ATTACHMENT 1

PROPOSED TECHNICAL SPECIFICATION CHANGE

NORTH ANNA UNIT NO. 1

6.0 ADMINISTRATIVE CONTROLS

Offsite Organization for Facility Management and Technical Support

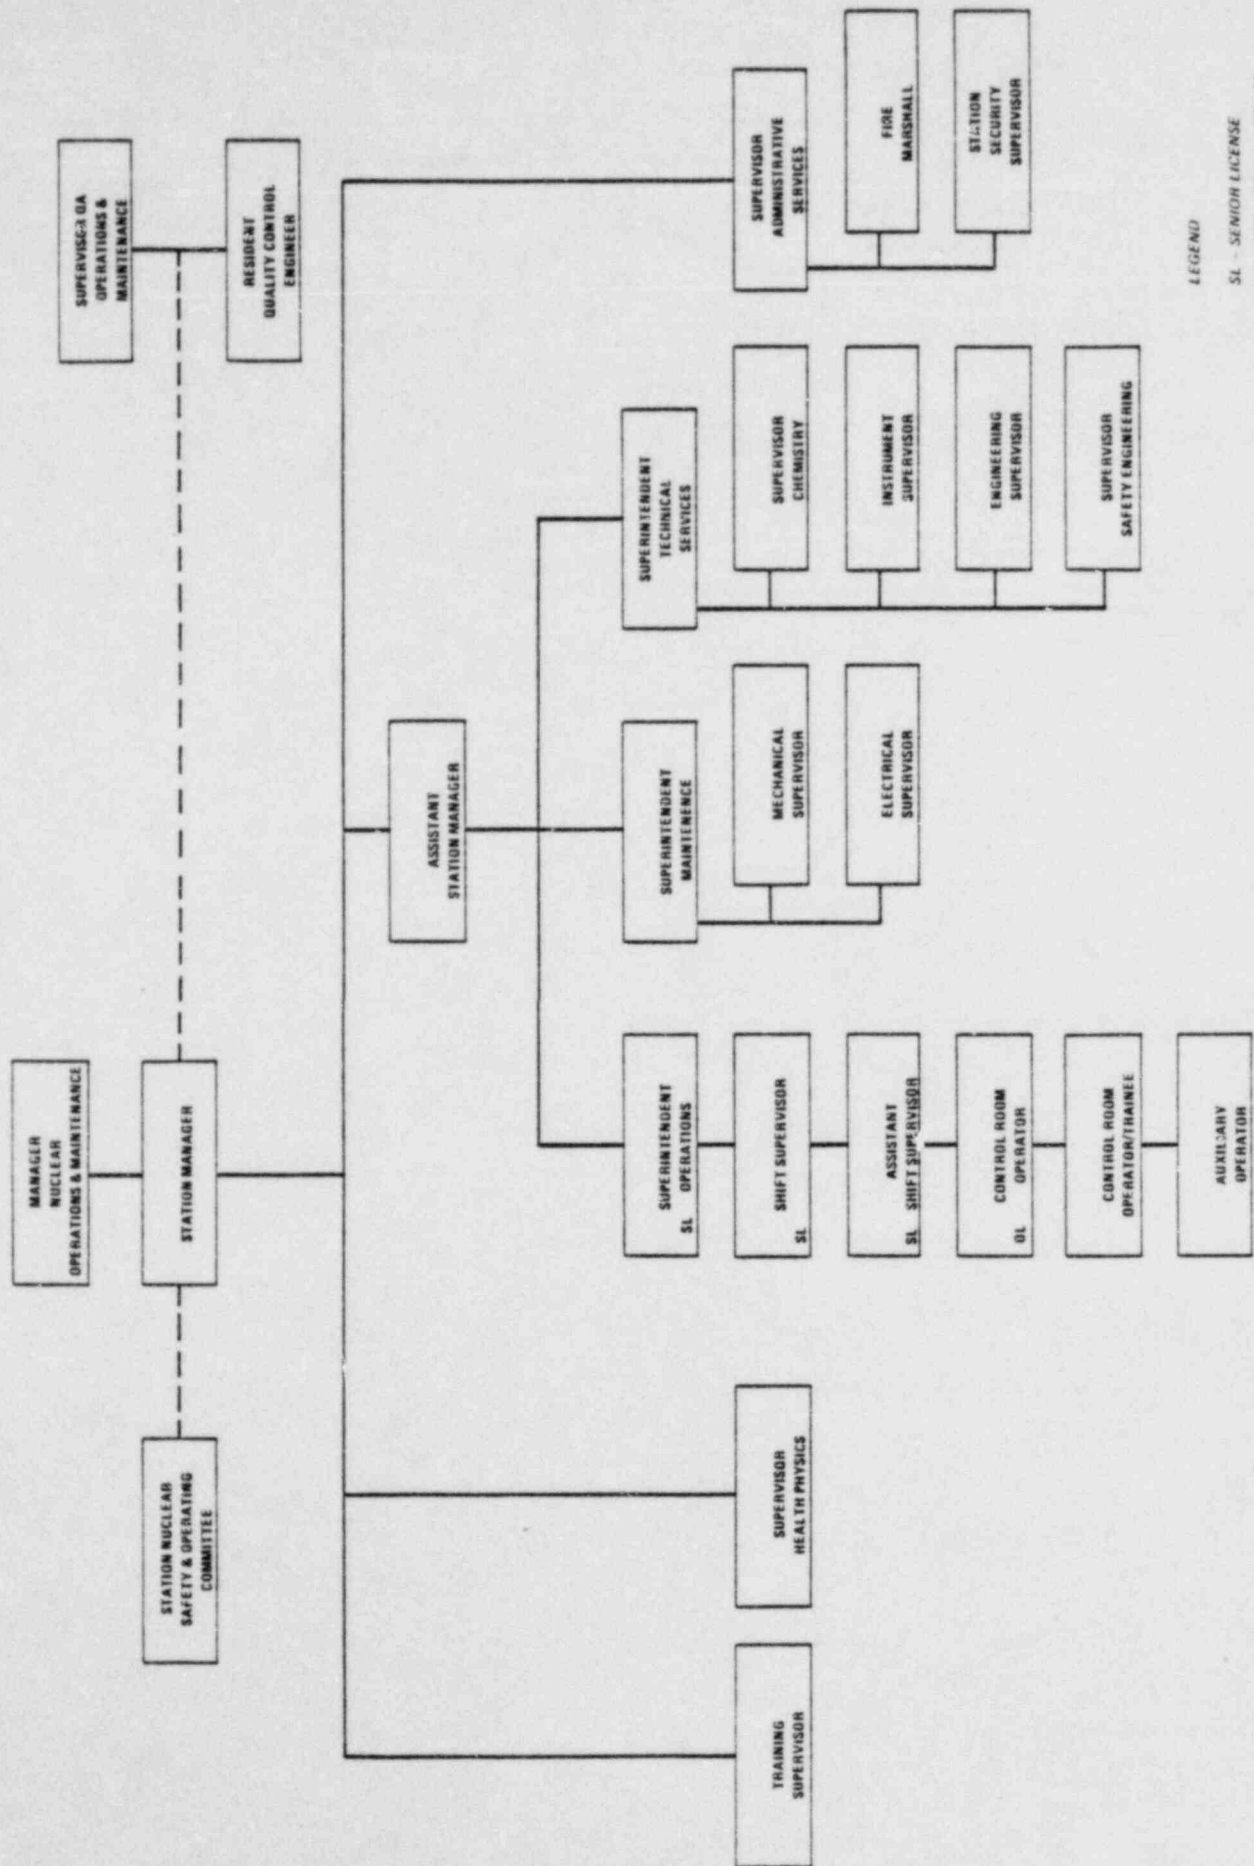
6.2.1 The offsite organization for facility management and technical support shall be as shown on Figure 6.2-1.

Figure 6.2.2 Facility Organization - North Anna - Units 1 & 2

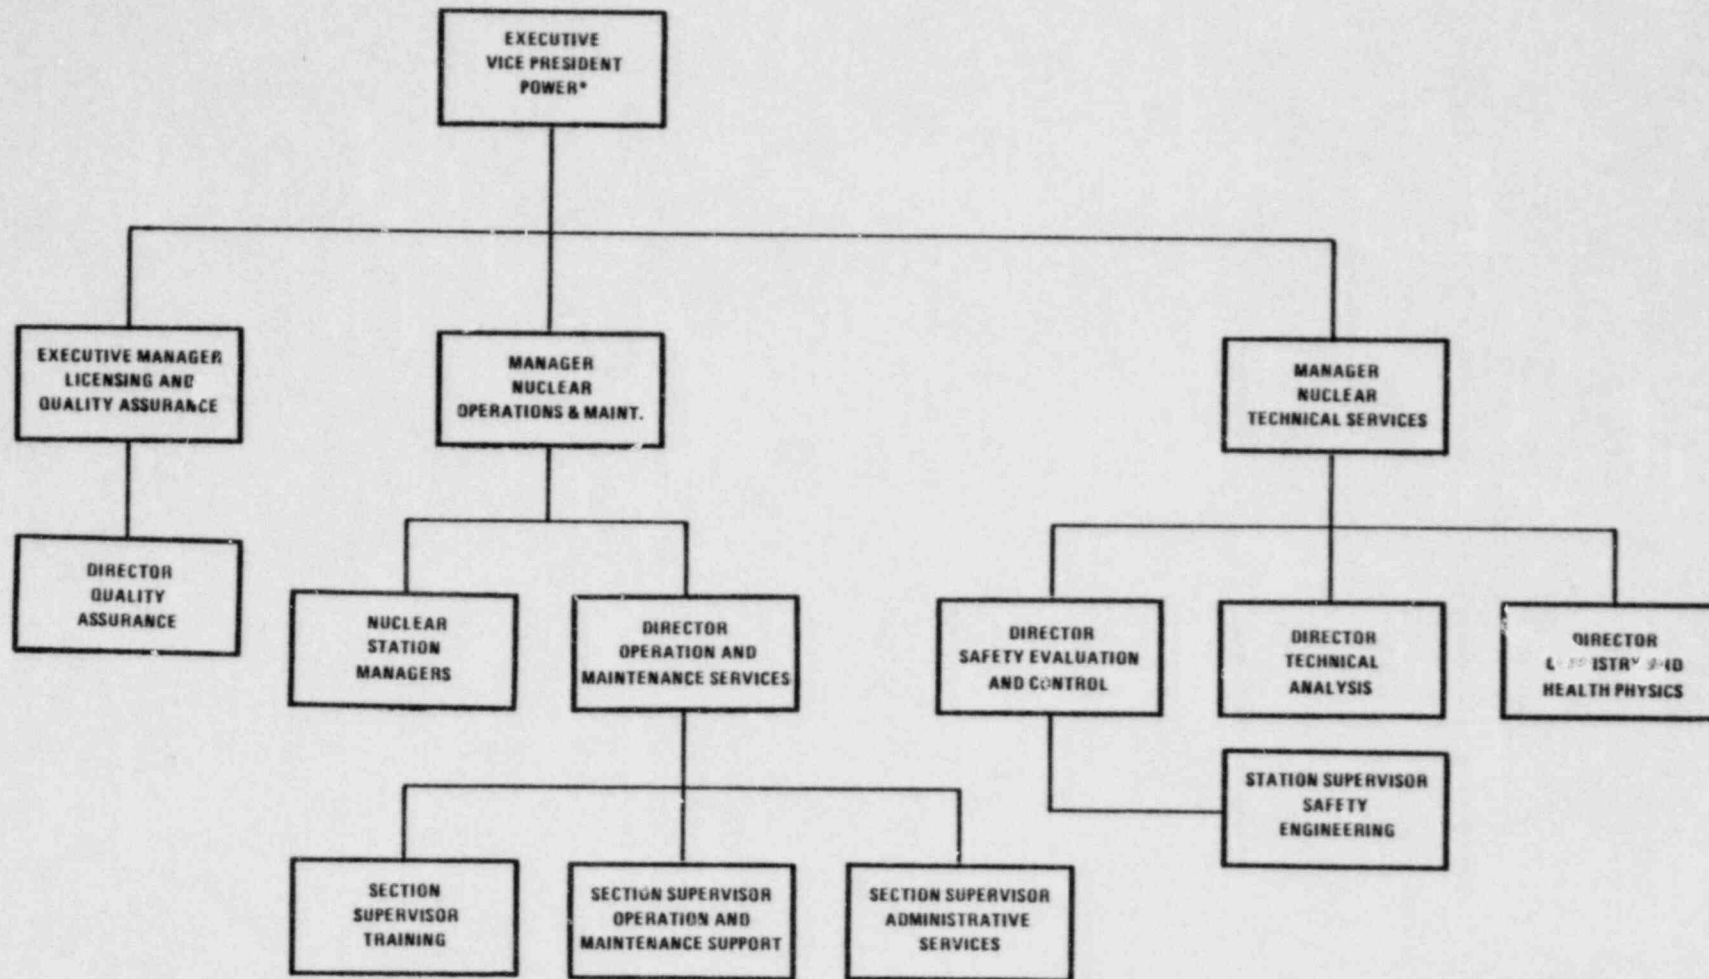
6.2.2 The Facility organization shall be as shown on Figure 6.2-2 and:

Figure 6-2 Facility Organization - North Anna - Units 1 & 2

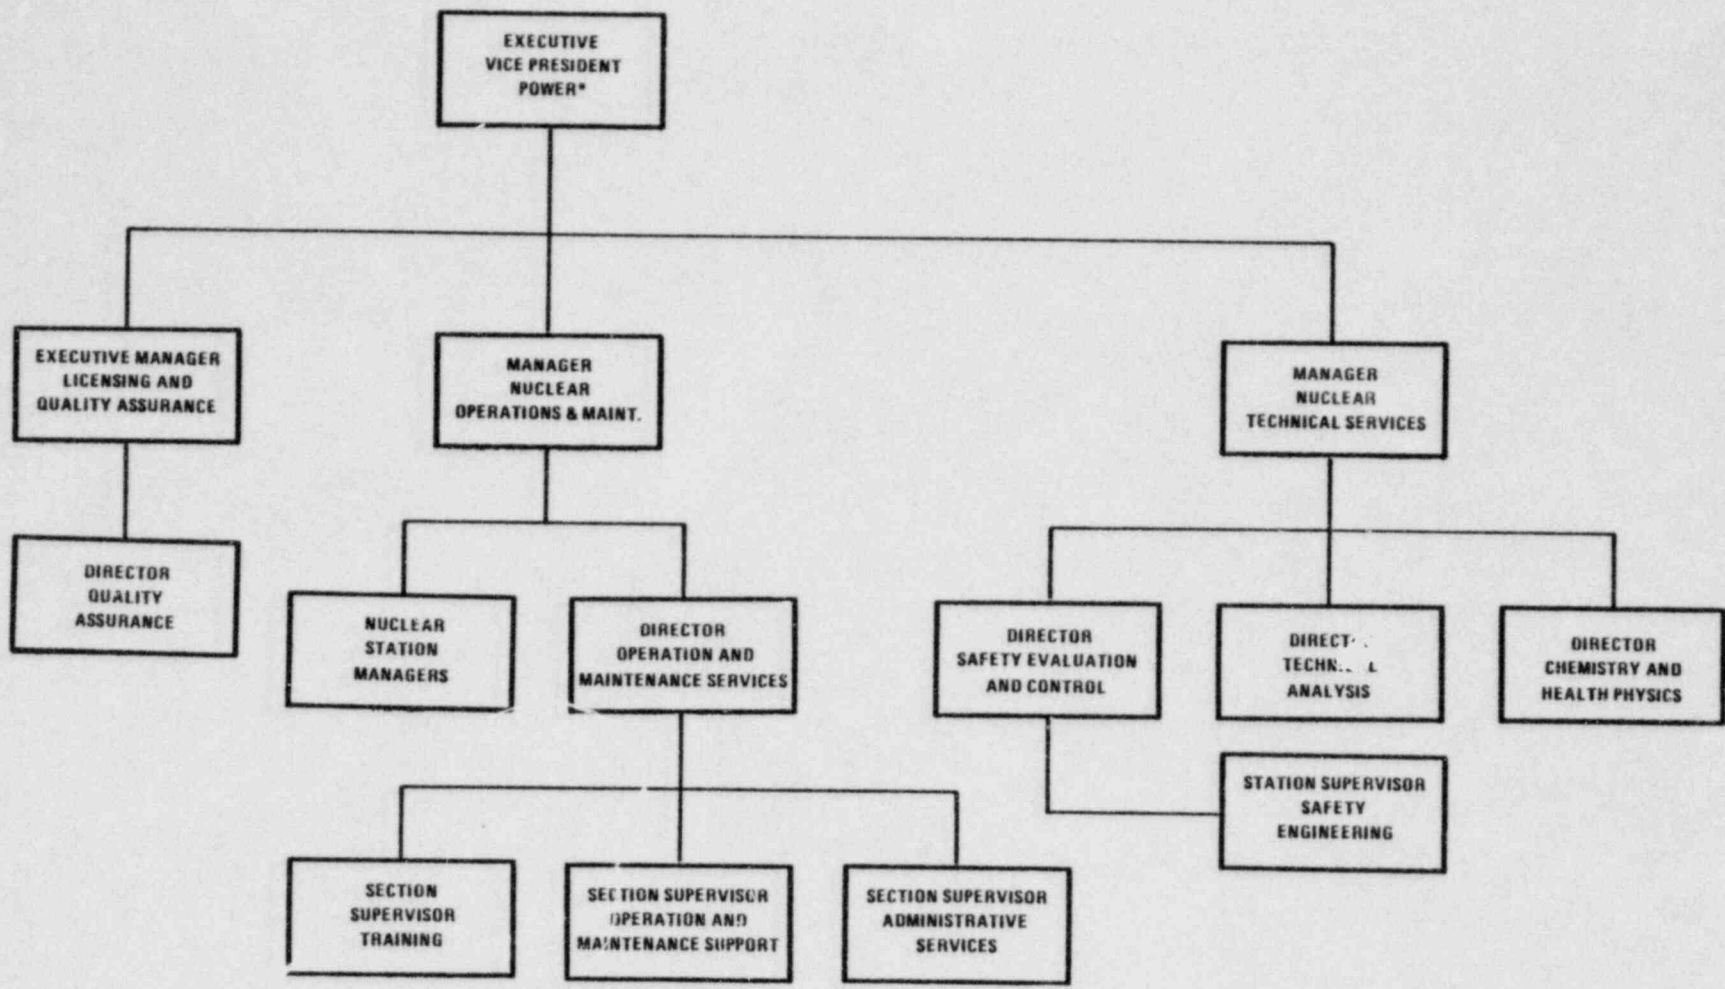
6.2.2 The Facility organization shall be as shown on Figure 6.2-2 and:

Offsite Organization for Facility Management and Technical Support

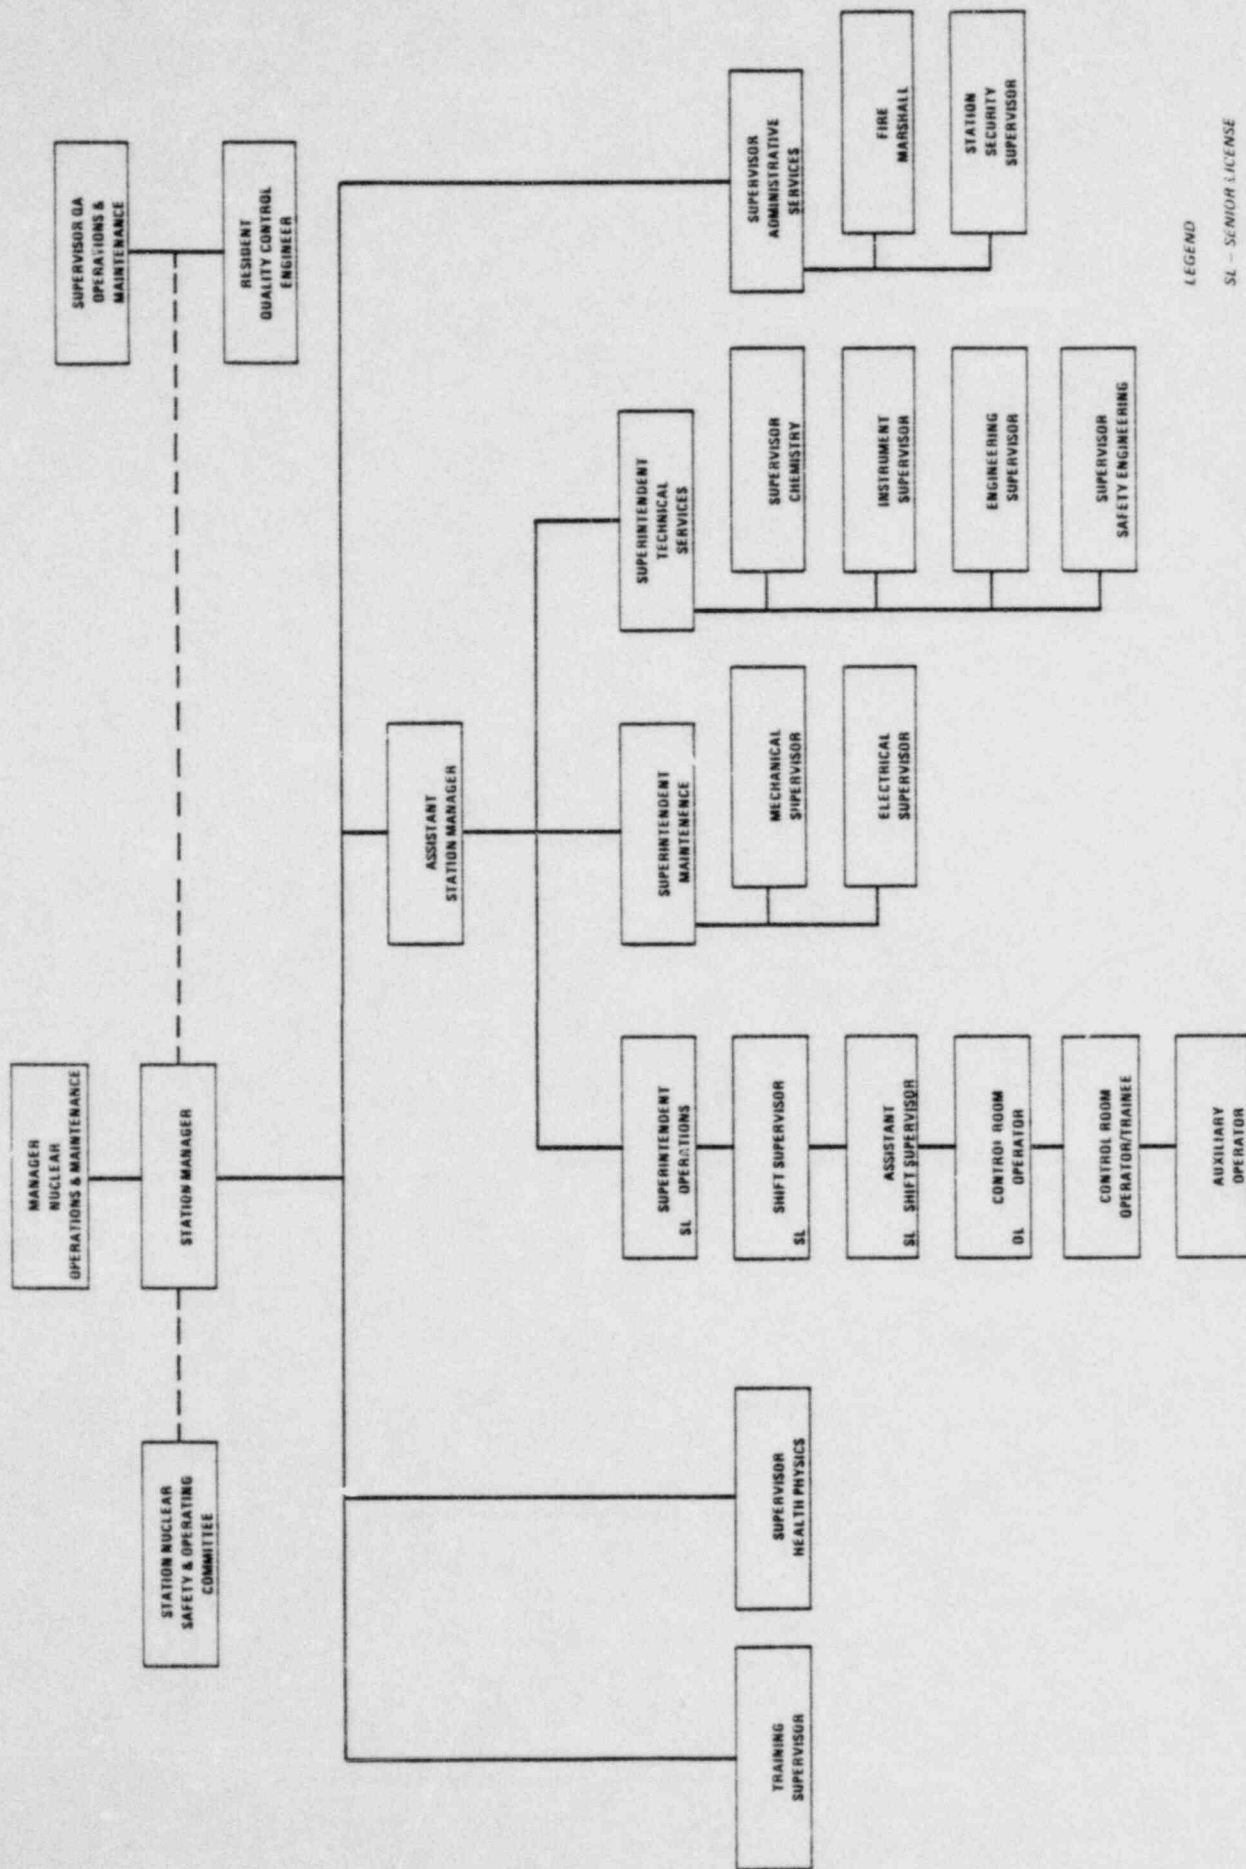
6.2.1 The offsite organization for facility management and technical support shall be as shown on Figure 6.2-1.
